80-88 Regent Street, Redfern

Response to Submissions

August 2016

Figure 3: Amendment to setback to tower on Marian Street

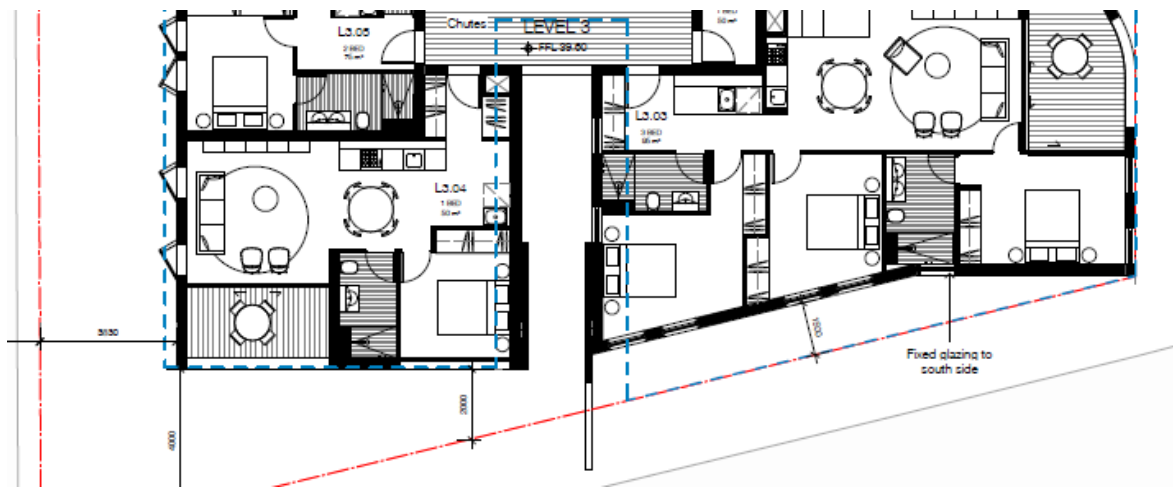
Tower setbacks to Marian Street

The amended proposal does not fully comply with the 4.0m Marian Street tower setback, as illustrated in Figure 3. However the extent to which the tower encroaches into this setback has been reduced from levels 3 to 17 in comparison to the original DA. (Note: the blue outline indicates the footprint of the tower in the original DA submission) As detailed in Table 6, the tower setback which previously varied from 0m to 4.0m, has been principally increased to a minimum setback of 1.5m up to 4.0m. This excludes a small section towards the corner of Marian and Regent Street.

Figure 4: Tower setbacks to Regent Street – Level 2

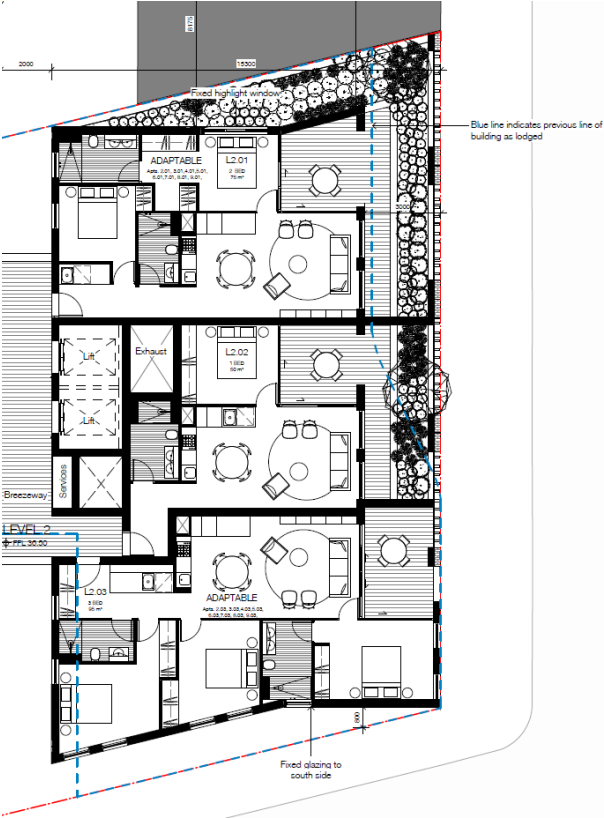
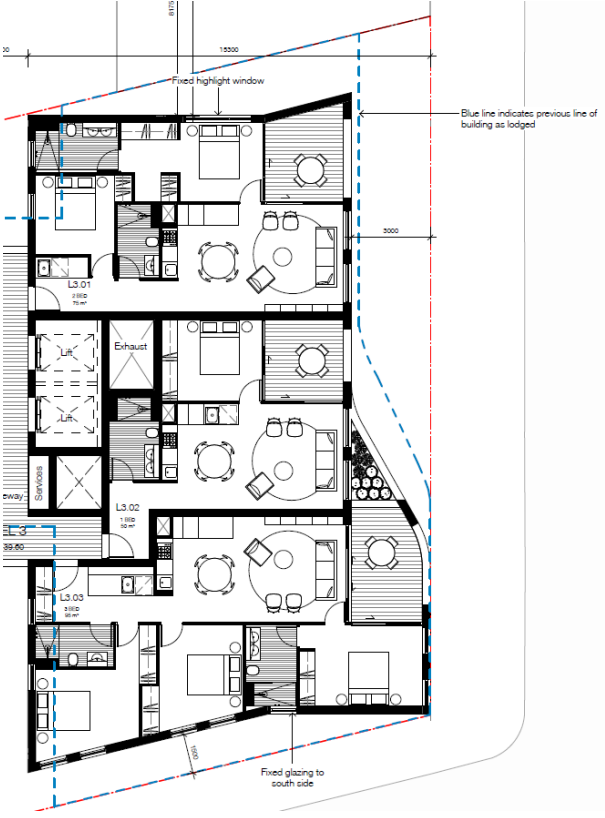
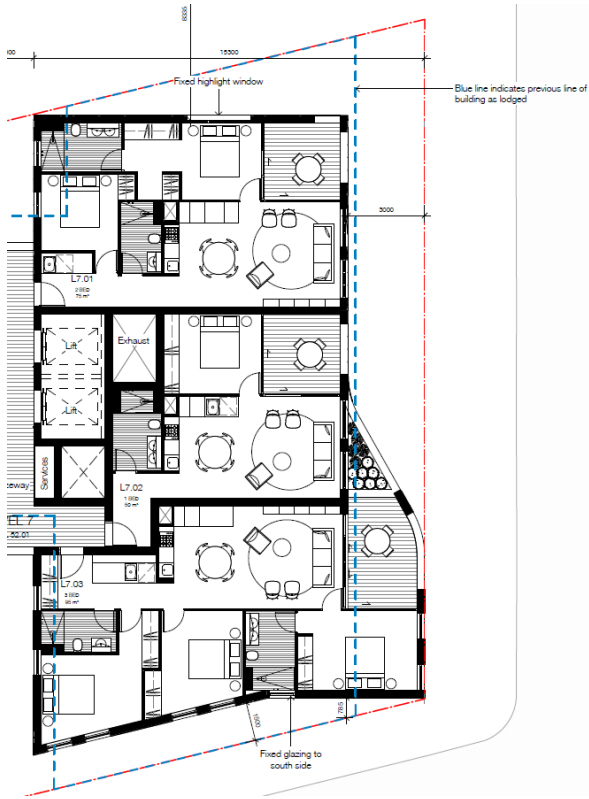
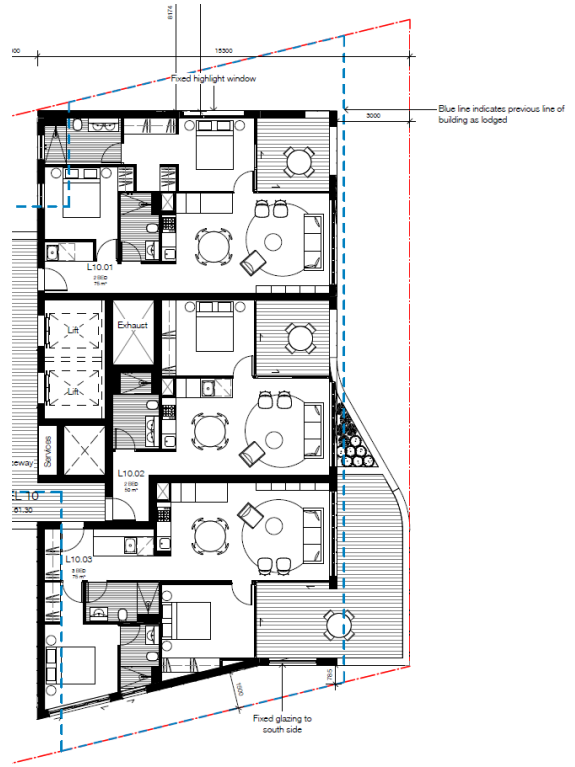
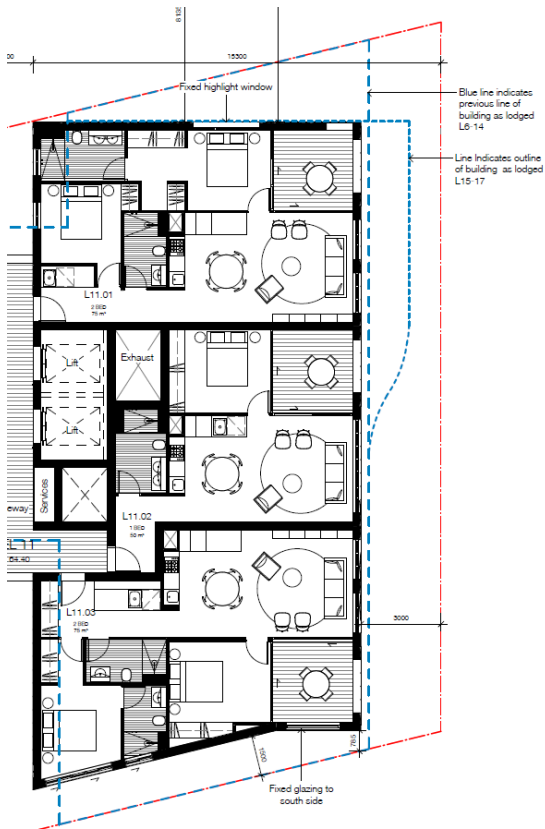
Under SEPP (SSP) 2005, a two (2) storey height limit applies to Regent Street, which has a depth of 8.0m. This translates to an 8.0m setback to the 18 storey tower element.

The original DA did not comply with the 8.0m setback with a variable setback to Regent Street ranging from 0m to 2.85m. The 2.85m setback was in keeping with the 3.0m tower setback that was provided for the approved Iglu development at 60-78 Regent Street. A similar setback has been provided for the proposal, however as illustrated in Figures 4 to 8 and Table 7, the locations of the 0m setback have been relocated from the northern part of the elevation adjoining Iglu to the corner of the elevation. Furthermore, the upper levels of the building no longer encroach into the 3.0m setback. Furthermore the 2.85m setback has been increased to 3.0m so that it aligns with the Iglu development.

Figure 9: Proposed separation distances level 2-9

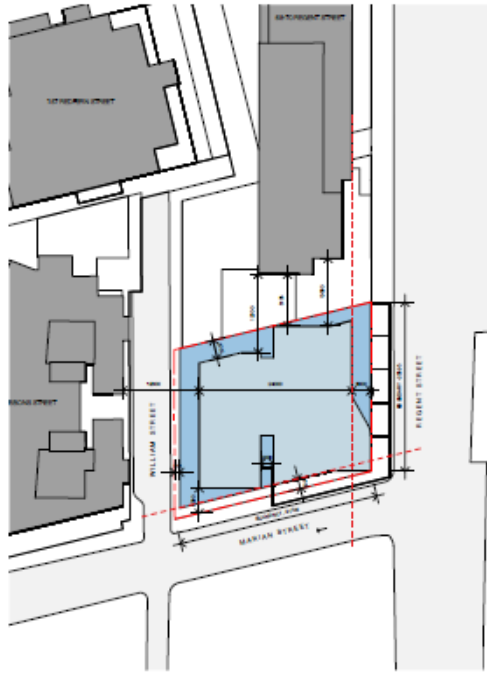
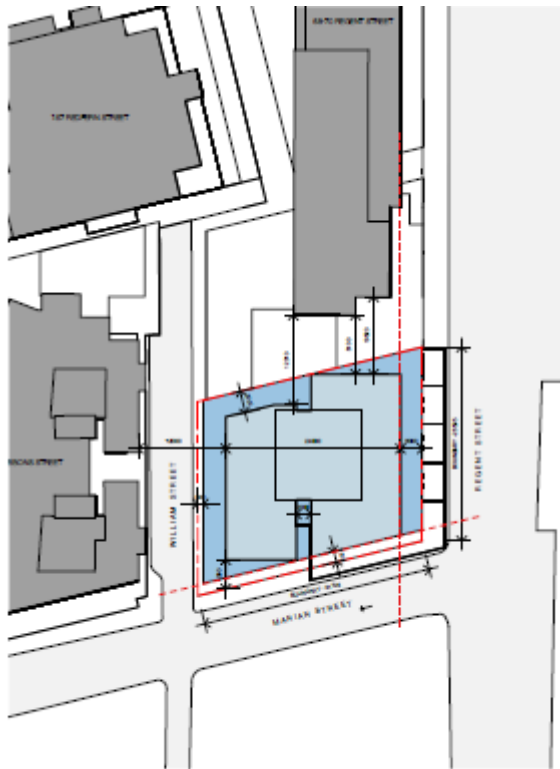
- Additional justification is required to demonstrate how the proposed built form and setbacks have considered, addressed and minimised impacts on adjacent residential amenity, including privacy, views, outlook, ventilation and solar access, and specifically, how the proposed built form and setbacks do not increase amenity impacts beyond those envisaged by the planning controls for the site.

An amended built form was formulated which provided for a 1.5m increase in the setback to the adjoining Iglu development on levels 2-14 of the proposal. The tower setback to Marian Street was also increased to 1.5m, with the exception of the corner, to provide a variable setback ranging from 1.5m to 4m, and allow for increased separation distances to future development to the south. The north-western corner of the building was setback a further 0.3m to provide a 3.0m setback. These increased setbacks have, in part, been facilitated by the provision of a strong corner element, with reduced setbacks on Marian and Regent Streets.

There was very little scope to increase separation distances to 7-9 Gibbons Street to the west and provide a viable floor plate. Table 8 provides a comparison of the separation distances and setbacks between the original DA and the proposed amended DA. The proposed separation distances are illustrated in the extracts of the Built Form Analysis at Figures 9 and 10.

Figure 18: Highlight windows and only small balcony openings to apartments on levels 7-17 facing the Iglu development

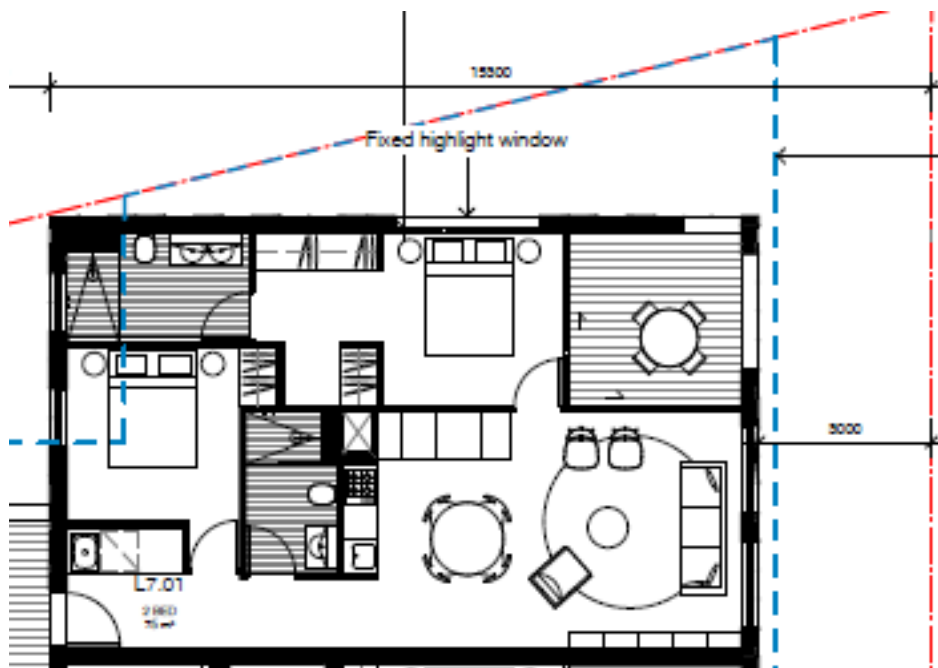
The submission prepared on behalf of Iglu raised concerns in relation to privacy impacts. To address these concerns a number of amendments were made to the proposal including:

- The Level 2 apartment in the northwest corner has been removed to mitigate any possible privacy impacts on the communal courtyard at level 1 podium;
- Fixed highlight windows are provided to bedrooms within the northern elevation to prevent direct views into the Iglu development;
- The setback to the northern elevation has been increased by 0.3m-1.5m;
- All balconies are oriented towards Regent Street, with only small openings located on the northern elevation (refer to Figure 18); and
- The deletion of the mezzanine levels and lowering of the building has also reduced privacy impacts.
